PLANNING APPROVAL,
PLANNED UNIT DEVELOPMENT &
SUBDIVISION STAFF REPORT

<u>NAME</u>	Weinacker's Montessori School, Inc.
<u>SUBDIVISION NAME</u>	WMSHC Subdivision
<u>LOCATION</u>	227 Hillcrest Road (East side of Hillcrest Road, 625'± South of Cedar Bend Court)
<u>CITY COUNCIL DISTRICT</u>	District 5
<u>PRESENT ZONING</u>	R-1, Single-Family Residence District
<u>AREA OF PROPERTY</u>	1 lot / 1.6 acres ±
<u>CONTEMPLATED USE</u>	Planning Approval to allow a school in an R-1, Single-Family Residential District, Planned Unit Development approval to allow multiple buildings on a single building site, and Subdivision approval to create one legal lot.
<u>TIME SCHEDULE FOR DEVELOPMENT</u>	Immediate
<u>ENGINEERING COMMENTS</u>	No fill allowed in AE flood plain without compensation. Show minimum finished floor elevation on each lot in AE flood plain. No detention is allowed in the AE flood plain. Must comply with all storm water and flood control ordinances. Any work performed in the right of way will require a right of way permit.

SITE PLAN

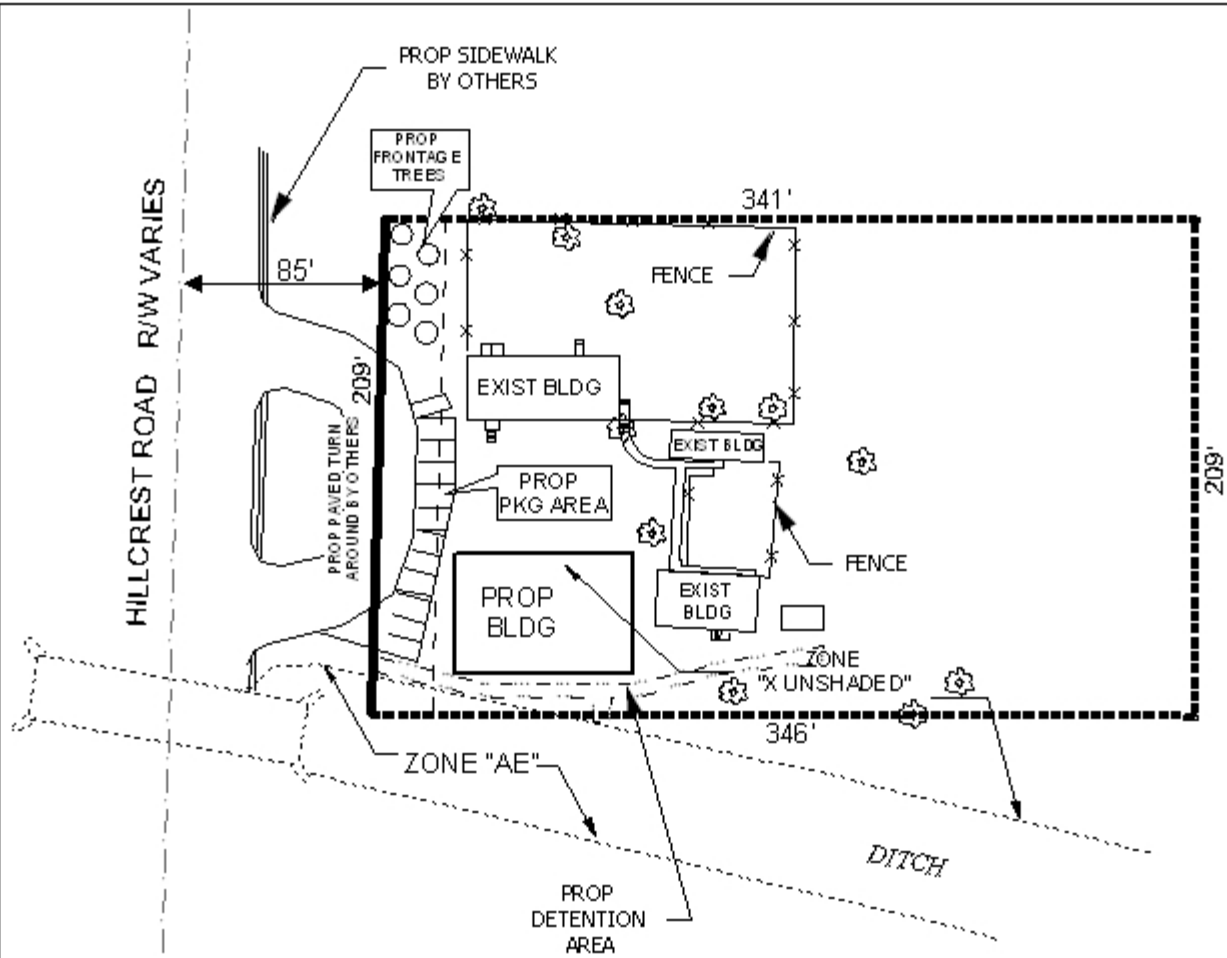
The proposed site plan depicts a new 3000 to 4000 square foot building, a widened access drive from Hillcrest Road, and 12 new parking spaces. The applicant proposes to add 2 to 3 new classrooms within the new building, extend the grades served from Kindergarten through 3rd grade, and increase enrollment to approximately 125 students.

The Zoning Ordinance requires 1 ½ parking spaces per teaching station, and it appears that the applicant will provide two teachers per classroom with the expansion. With a total of 6 classrooms, 12 teachers can be anticipated, thus 18 parking spaces should be provided. Additionally, parking areas with more than 10 spaces must be illuminated if the parking area is used at night, in compliance with Section 64-6.A.3.c. of the Zoning Ordinance.

It also appears that several of the proposed parking spaces will require drivers to back into the right-of-way for Hillcrest Road. While the right-of-way at this location is approximately 150 feet wide, much wider than the 100 feet recommended by the Major Street Plan component of the Comprehensive Plan, backing into the right-of-way is not permitted by Section 64-6.A.2. of the Zoning Ordinance. The parking area should be redesigned so that all circulation related to parking and pick-up and drop-off activities occur fully on the site, and that the dimensions for the parking and circulation comply with the standards listed in the Zoning Ordinance.

A dumpster or other waste facility is not depicted on the site plan, however, it is assumed that wastes are generated by the site. Since the site is a commercial use, waste must be removed from the site by a private service, thus if dumpsters are used, they must comply with the screening requirements of the Zoning Ordinance and be depicted on the site plan.

Finally, a protection buffer strip should be provided along the North, East and South perimeters of the site, in accordance with Section 64-4.D.1. of the Zoning Ordinance.

- 1) The proposed parking and circulation improvements will not comply with the requirements of the Sections 64-6.A.2. and 64-6.A.6. of the Zoning Ordinance;*
- 2) Insufficient parking will be provided for the proposed uses; and*
- 3) other site improvements necessary to comply with the Zoning Ordinance are not depicted on the site plan.*

- 1) The proposed parking and circulation improvements will not comply with the requirements of the Sections 64-6.A.2. and 64-6.A.6. of the Zoning Ordinance;*
- 2) Insufficient parking will be provided for the proposed uses; and*
- 3) other site improvements necessary to comply with the Zoning Ordinance are not depicted on the site plan.*
